101 Albert Street – Flood Engineering

PLANS AND DOCUMENTS  
referred to in the FDA  
DEVELOPMENT APPROVAL

# TMR INFORMATION REQUEST

**Table 1: TMR Information request and responses**

**Figure 1: Extent of detailed site survey (17/05/2022 / highlighted in green) adopted for the flood modelling base case scenario**

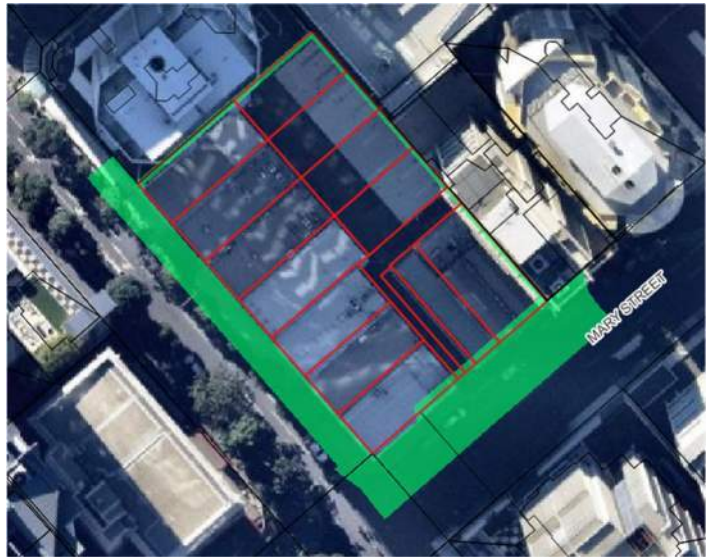
Demonstrate that a pre-Cross River-Rail construction base case has been used for the flood modelling. It is unclear whether the base case used is pre-Cross River Rail construction (circa 2018) or whether what is modelled is there now (Cross River Rail temporary works). Section 3.2.4 states that they have cut into the existing model a 'detailed site survey' but the date of this survey is not provided. If the pre-construction base case has not been used, please contact the Cross River Rail Development Authority to obtain this (info@crossriverrail.qld.gov.au) and revise the model.

The flood modelling base case adopted for this flood impact assessment is as described in Section 3.2 of this report (Revised Existing Case Scenario), comprising a hybrid between:

- Existing site conditions (Cross River Rail temporary works) at the verge fronting the site, per a detailed site survey dated 17/05/2022,
- Pre-construction site conditions (LiDAR data from 2014) for the Albert Street carriageway.

This is a suitable baseline as it is a reasonable representation of the expected Albert Street corridor design once Cross River Rail works have been finalised.

The extent of the detailed site survey (dated 17/05/2022) is highlighted in green in Figure 1 below. The remaining flood model (excepting specific building modifications described in Section 3.2 of this report) is based on a LiDAR data from 2014, per the Brisbane City Council Citywide Creek & Overland Flow Path Mapping Central sub-model (TUFLOW), prepared by Brisbane City Council and GHD Pty Ltd in April 2017.
